Engineering Referral Response

Application Number:	DA2024/1362
Proposed Development:	Demolition works and construction of mixed use hospitality venue with supporting car parking, servicing and landscaping works
Date:	03/12/2024
To:	Anne-Marie Young
Land to be developed (Address):	Lot 180 DP 752017 , 40 Myoora Road TERREY HILLS NSW 2084

Council's Indicative Drainage Infrastructures Location

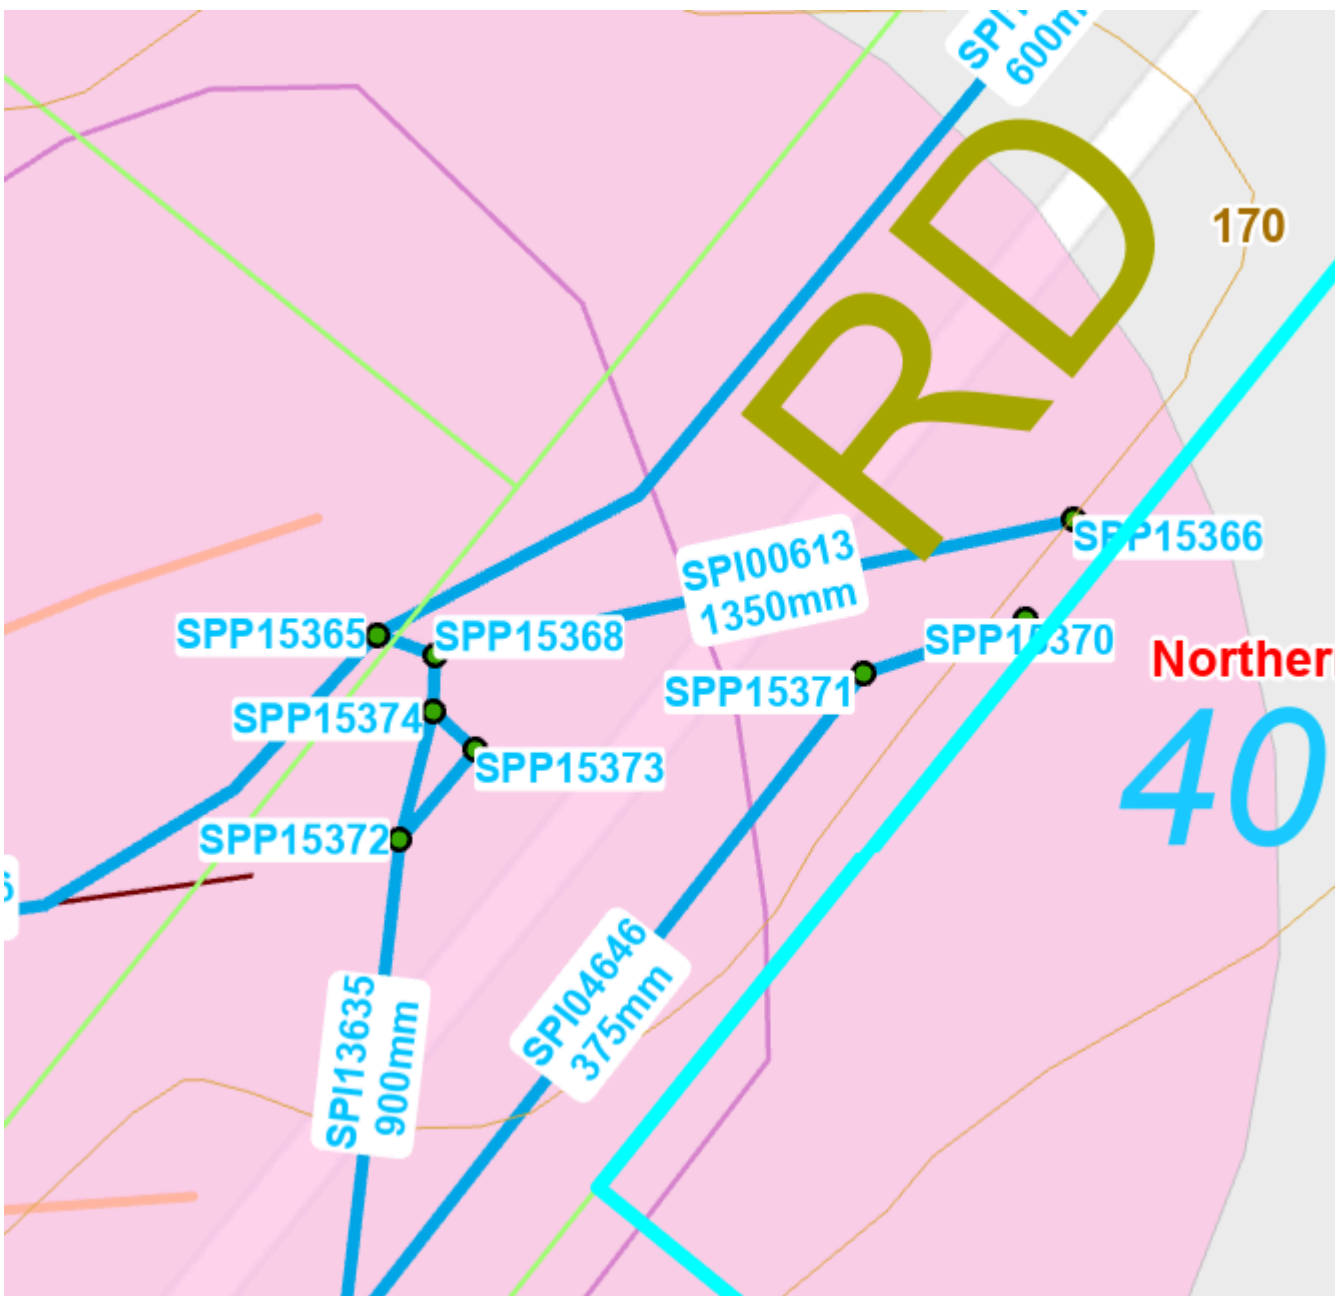
- According to Council's records, a Council's stormwater lintel pit connects to a 1350mm Council's channel chamber travelling across the road. Please discharge stormwater runoff from the subject site to this kerb inlet pit which will resolve the surcharge issue from the boundary pit. An indicative location of Council's drainage infrastructures is attached at the end of this referral letter.

- The 1350mm Council's channel chamber shown in Council's system is indicative only. A licensed plumber should investigate and locate this Council's channel chamber to double check its size, and to make sure it crosses Myoora Road and eventually goes to the creek.
